ITEM FOR ENVIRONMENTAL COMMISSION AGENDA

NAME & NUMBER OF PROJECT: 8020 Parmer Lane SH 130 NW
C8J-2021-0141.0A

REQUEST: Variance request is as follows:
1. Request to vary from LDC 30-5-341 to allow fill over 4 feet to 15 feet.
2. Request to vary from 30-5-261(G) to allow floodplain modification in a critical water quality zone buffer.

STAFF RECOMMENDATION: Staff recommends this variance, having determined the findings of fact to have been met.

EXHIBIT 4 – FLOODPLAIN MODIFICATION

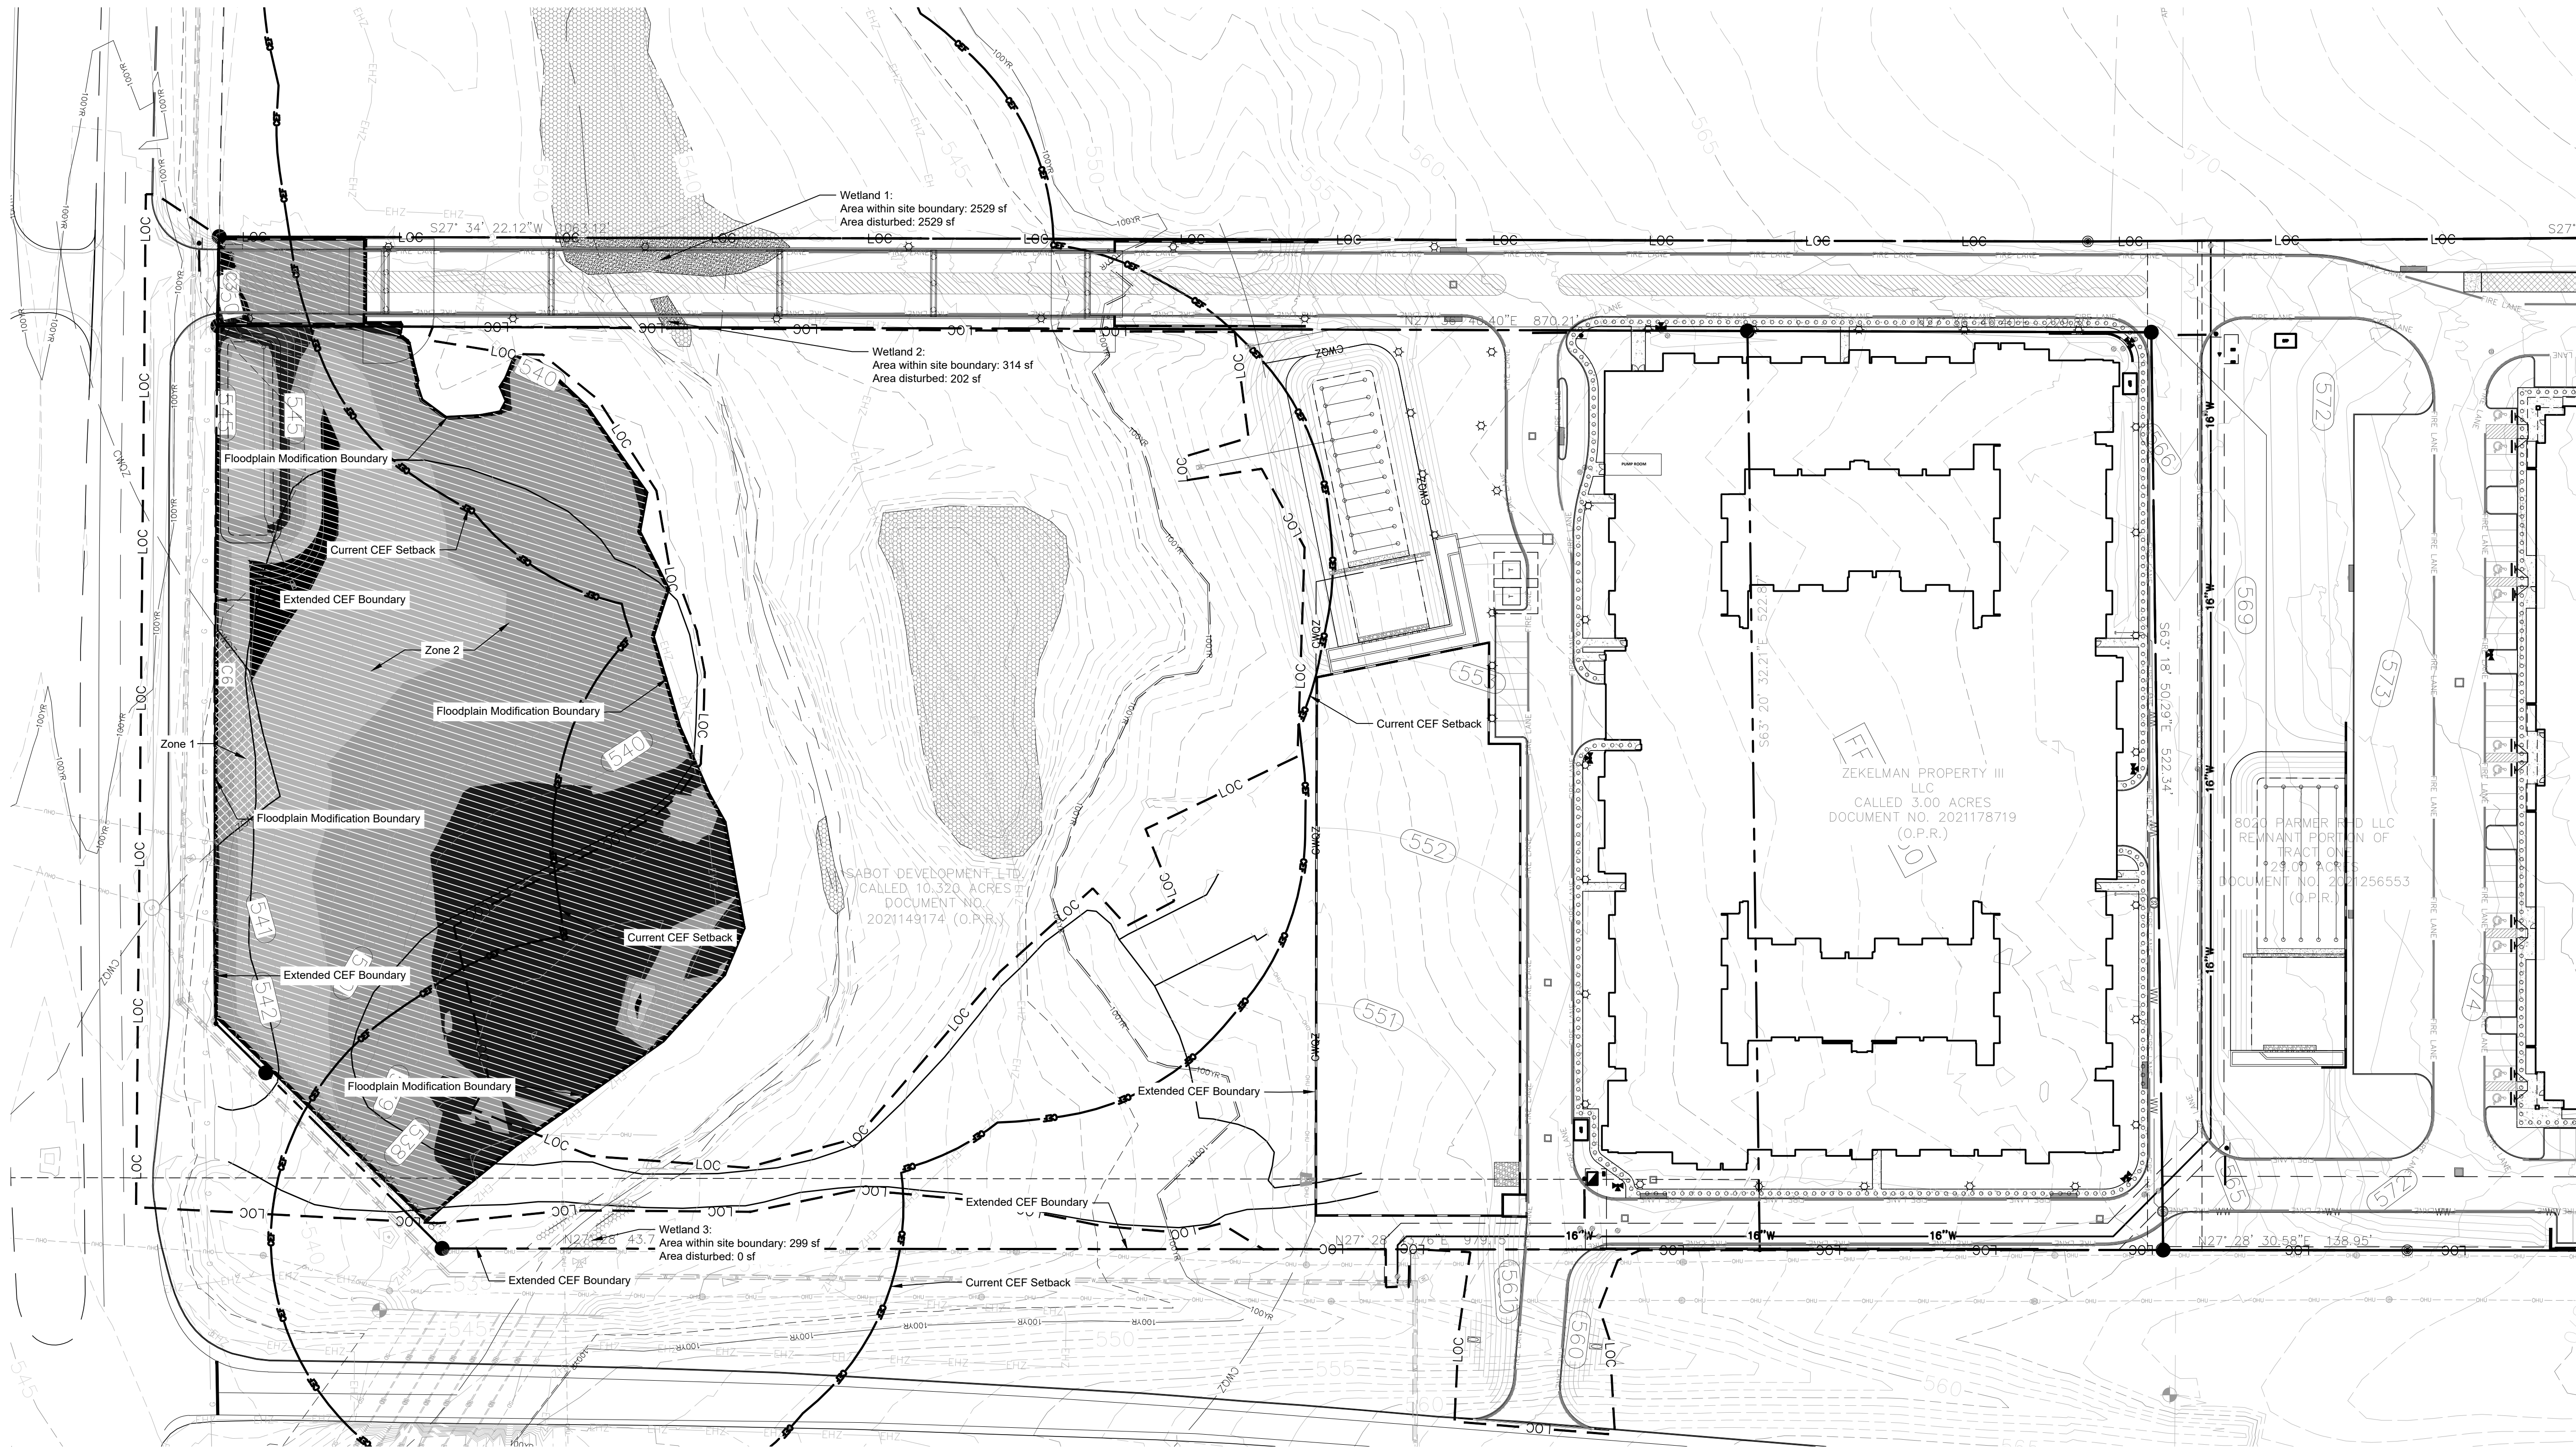
STAFF CONDITION: Staff recommends the following conditions:
1. The applicant will pay into the Riparian Zone Mitigation Fund for both the area of Zone 1 (Floodplain outside of the CWQZ) and the area of Zone 2 (Floodplain within the CWQZ) using the appropriate ratios per ECM 1.7.6.
2. Development of the site will be carried out as described in Exhibits 1-6, attached in the staff variance packet.

The Critical Water Quality Zone variance is required because floodplain modification is necessary to offset the floodplain volume displaced by the bridge. There are no adverse impacts proposed to the floodplain elevations on adjacent properties with the proposed improvements, per the requirements of the code.

Yes The proposed floodplain modification is the minimum necessary to build the bridge as required by code for safe access, with the low chord of the bridge two feet above the water surface elevation of the 100-year floodplain.
